June 15, 2017

**BOARD OF COUNTY COMMISSIONERS
ORANGE COUNTY, FLORIDA
ADDENDUM NO. 3 / IFB NO. Y17-763-PH**

**NORTHWEST WATER RECLAMATION FACILITY REUSE WATER STORAGE
IMPROVEMENTS**

VORTEX BAFFLE
DETAIL 1
 NTS M04

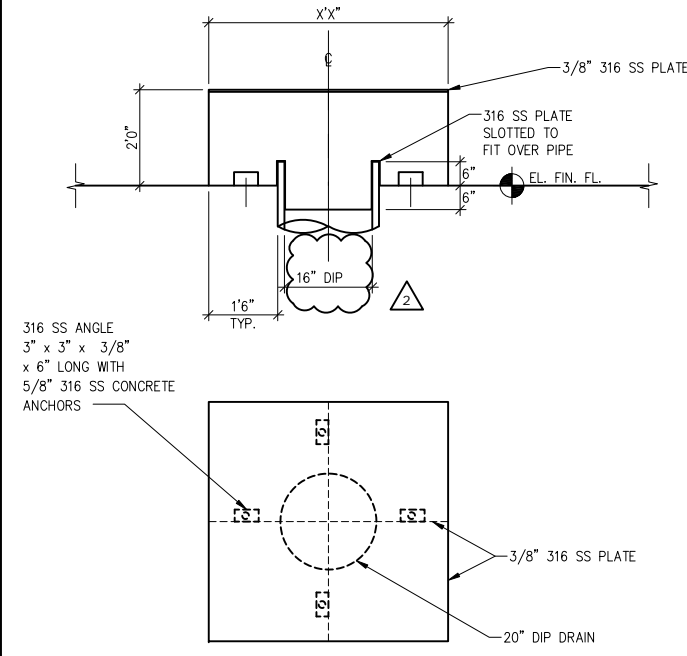
Question 19. Drawing Sheet M04, Detail 1, shows a 20" DIP drain for the vortex baffle. 20" pipe is not shown on any drawings, however, the 16" outlet is shown with a vortex baffle. Please confirm that the vortex baffle is for the 16" outlet pipe or the pipe is 20”.

The outlet pipe is 16-inches diameter. On Drawing M04, Detail 1, REPLACE the “20” with “16”.

OVERFLOW COVER 675
DETAIL 7
 1/2\"/>

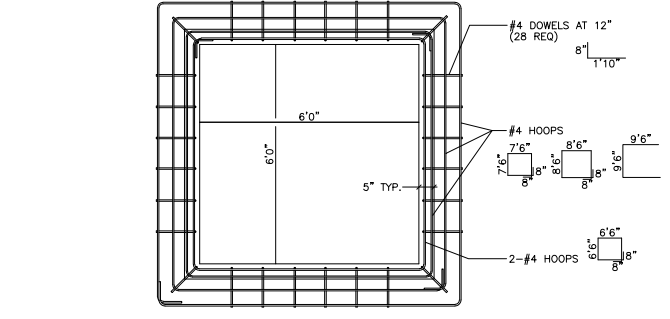
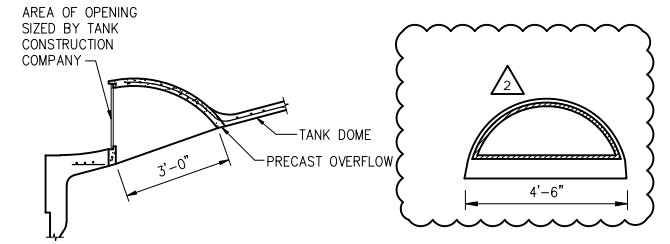
Question 12. Specification 13320-12, Section 2.16 A6, requires the dome overflows to have fiberglass “eyelid” covers over the overflow openings. Drawing sheet M04, Detail 7, shows a stainless steel security cover device. Both of these devices cannot be used together and is not required. Please remove all devices as the rain water must enter the tank freely and there is no concern for security on tanks of this type. Please reference Sand Lake Road – Two 10-MG GST’s recently constructed to confirm.

On Drawing Sheet M04, DELETE Detail 7 in its entirety.

DETAIL	4
N.T.S.	M09

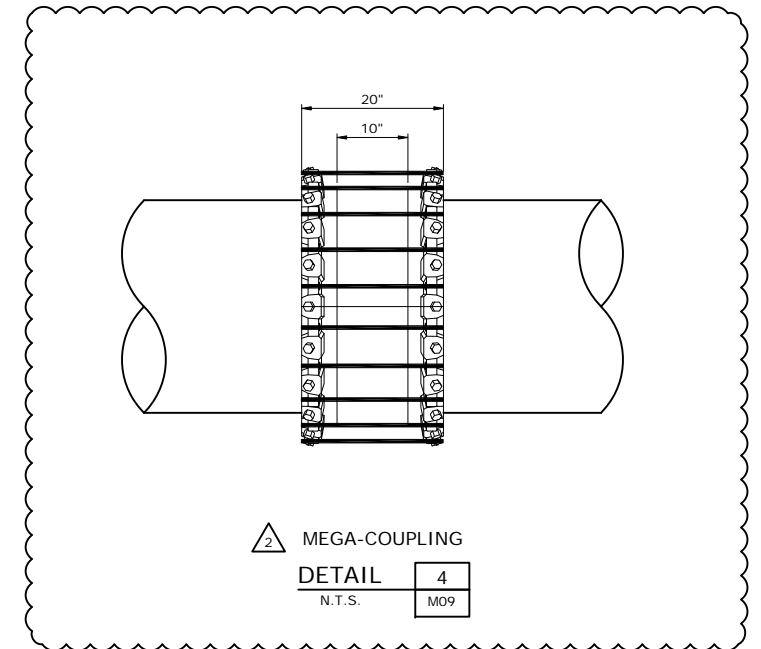
Question 40. Detail 4 on sheet M09 appears to be for a flanged coupling. Are mega-flanges required for this below-grade connection?

Question 42. Will MJ Solid Sleeves be allowed for final effluent line connections in lieu of Harnessed Flexible Couplings?

No. Mega-flanges are not required for this below grade connection. MJ solid sleeves or EBAA Iron Mega-Coupling Series 3800 are acceptable for making the final effluent piping connections. Refer to the enclosed Specification Section 15000 revisions. Refer to the revised Sheets C03 and M09 Detail 4.

Yes. MJ solid sleeves or EBAA Iron Mega-Coupling Series 3800 are acceptable for making final effluent line connections. Refer to the enclosed Specification Section 15000, Sheets C03 and M09, Detail 4 revisions.

REPLACE Drawing M09 with revised Drawing M09. Detail 4 is revised to show a Mega-Coupling in lieu of a harnessed flexible coupling.

DETAIL	8
NONE	M09

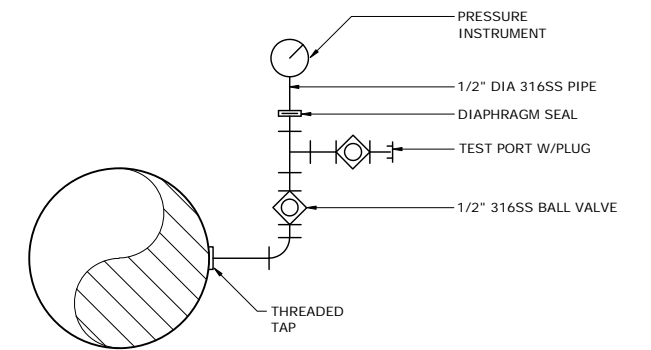
Question 52. The general section for the pumps refers to them coming with a pressure gauge with a diaphragm seal. The section then directs you to division 17 (17650 and 17698) for the specs on those gauges, however, those sections don't exist in the specs. There is only (1) gauge shown and it is located on the inlet to the Chlorine Booster Pump. The only detail for a pressure gauge in the drawings shows it as a side mounted gauge, and call for 316SS construction which is not consistent with the location or service for this gauge. Please provide clarification on the pressure gauge?

Drawing M06 calls for a side mounted pressure gauge to be located on the discharge side of each recirculation pump upstream from the check valve. The pressure gauges for both the recirculation pump station and chlorine booster pump are specified in Section 13650 Pressure Gauges. Refer to revised Section 11100 Pumps General.

DATE:	APRIL 2017
HAZEN NO.:	44014-001
CONTRACT NO.:	1
DRAWING NUMBER:	E-02

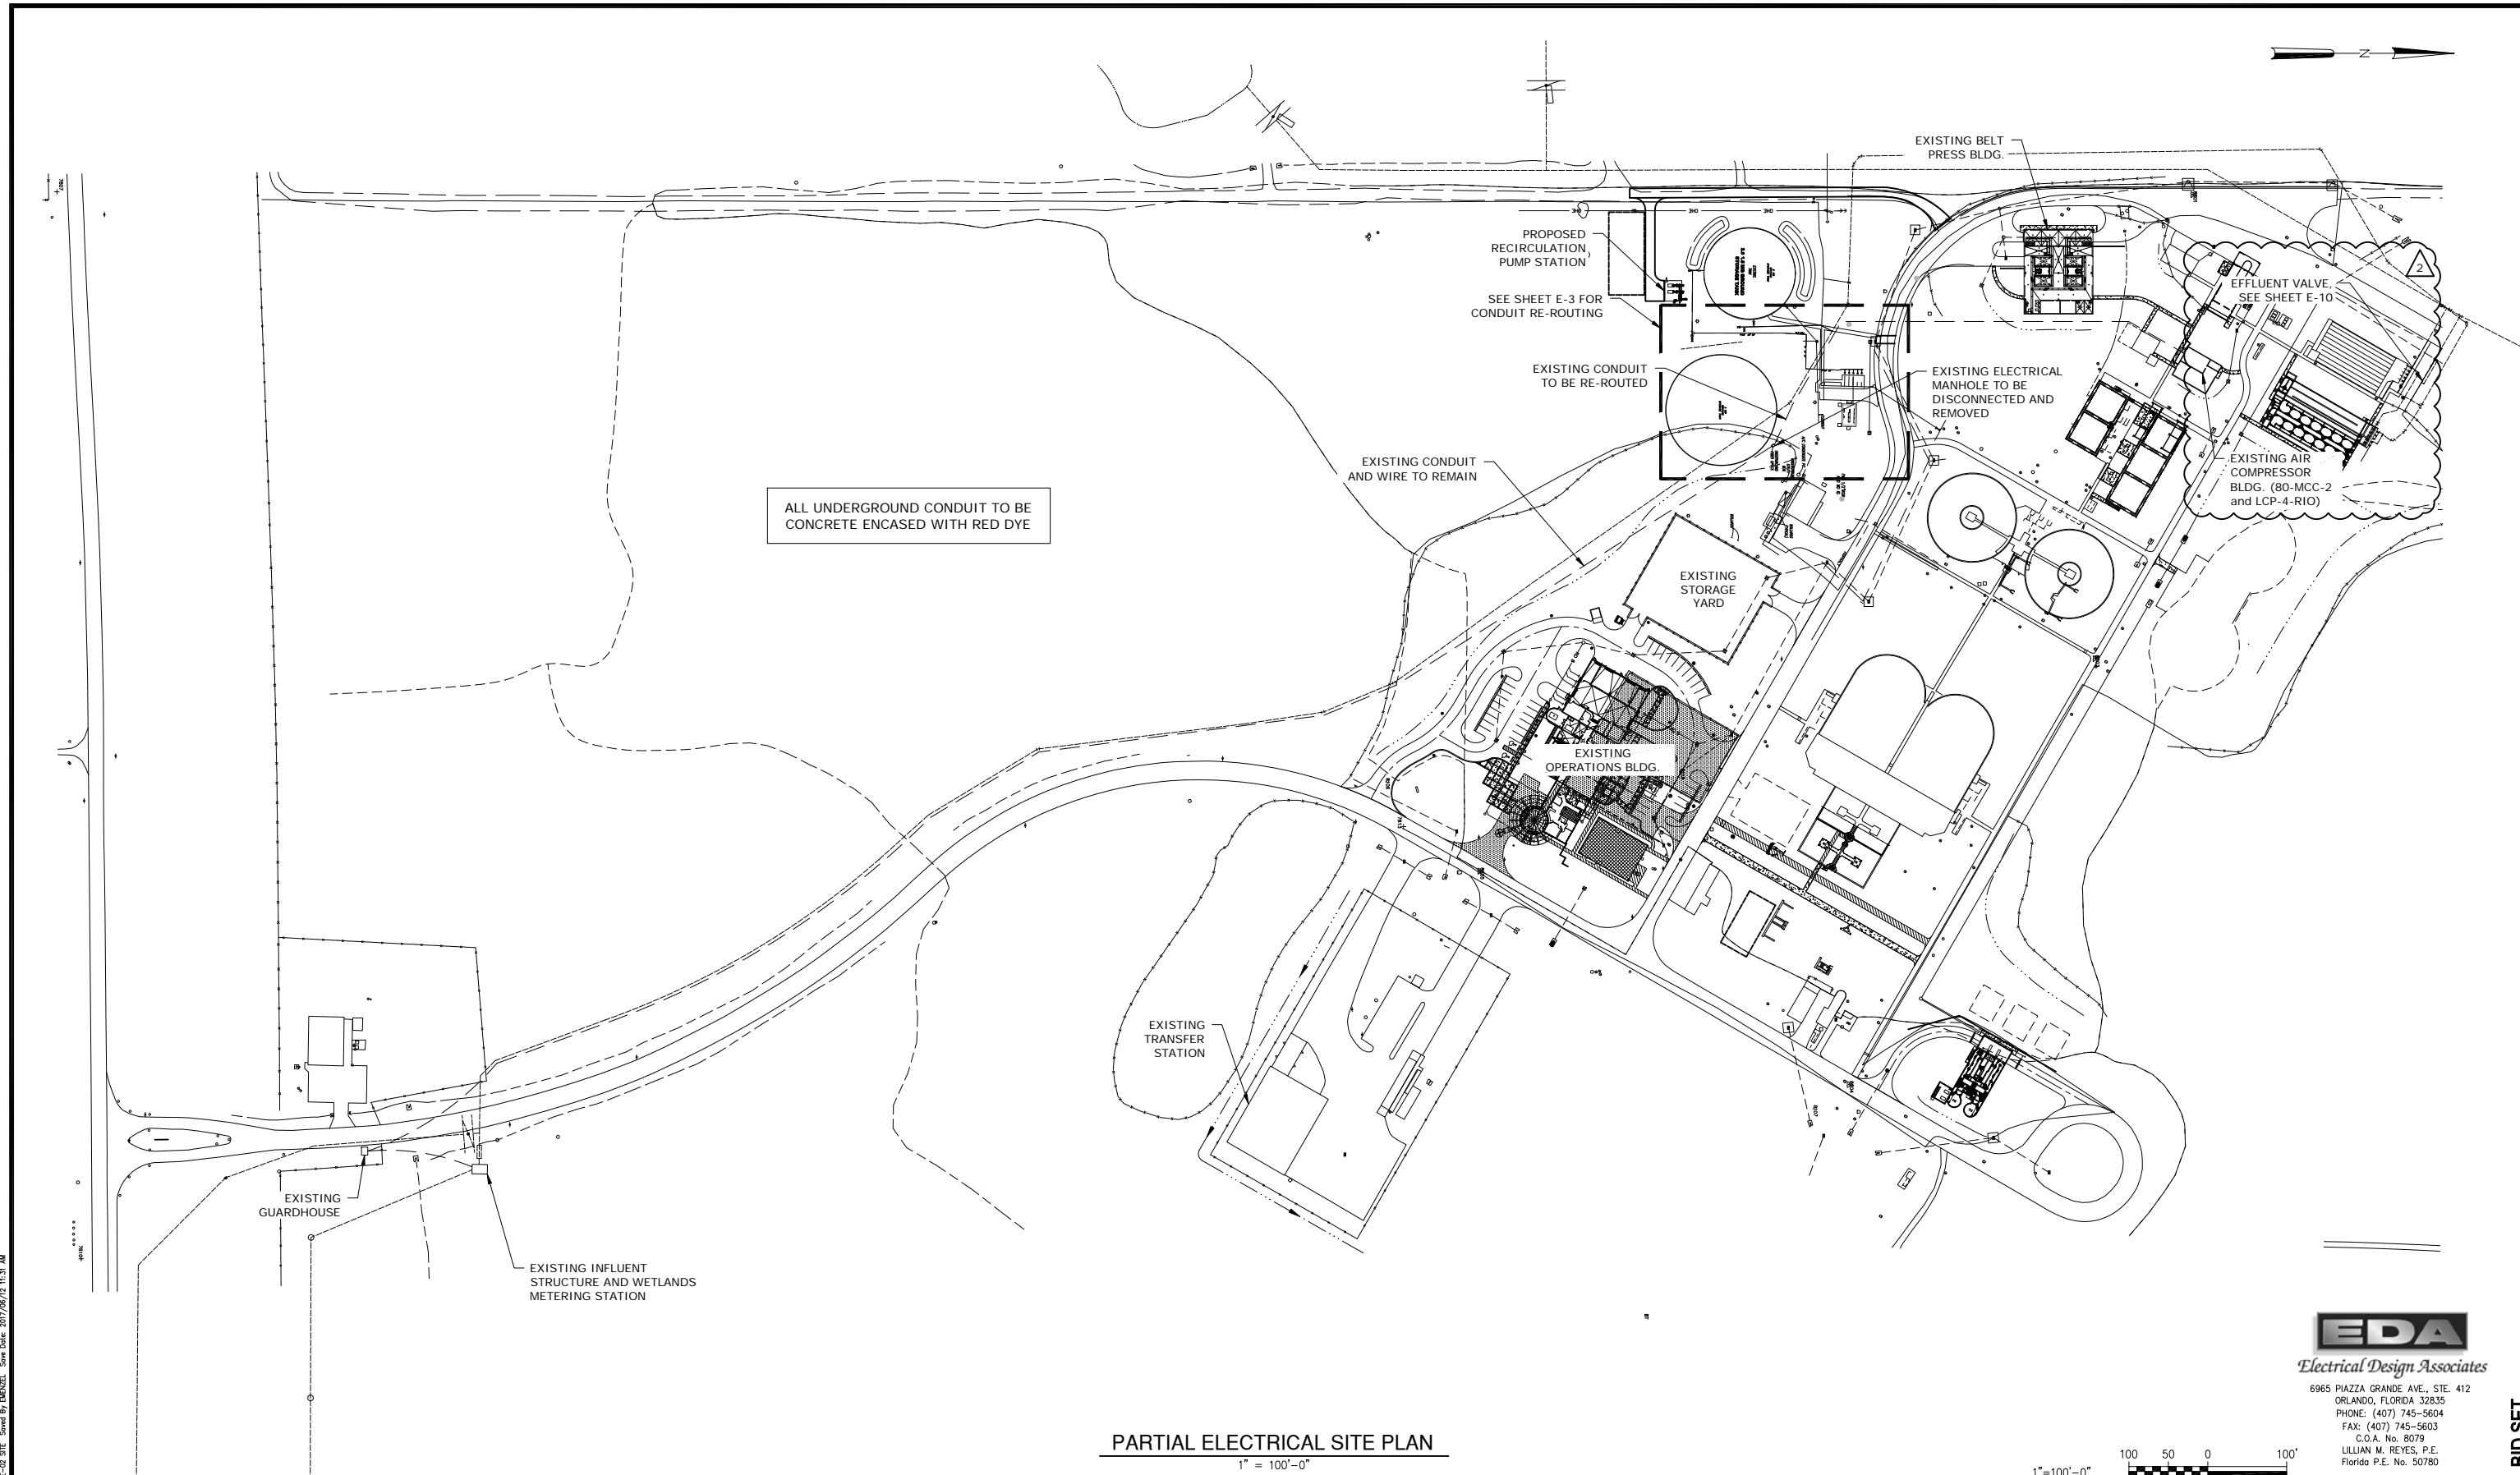
Question 34. Sheet E10 Effluent valve station building location is not clear on site plan. Please advise how far is 80- MCC-2 from effluent valve station. Please furnish the location of LCP-4-RIO.

The effluent valve is located on the north side of the chlorine contact chamber. 80-MCC-2 is located in the existing Air compressor building. LCP-4-RIO is located in the air compressor building. See revised drawing E-02.

REPLACE Drawing E-02 with revised Drawing E-02. The locations of the effluent valve and Air Compressor Building which houses 80 MCC-2 and LCP-4-RIO are identified.
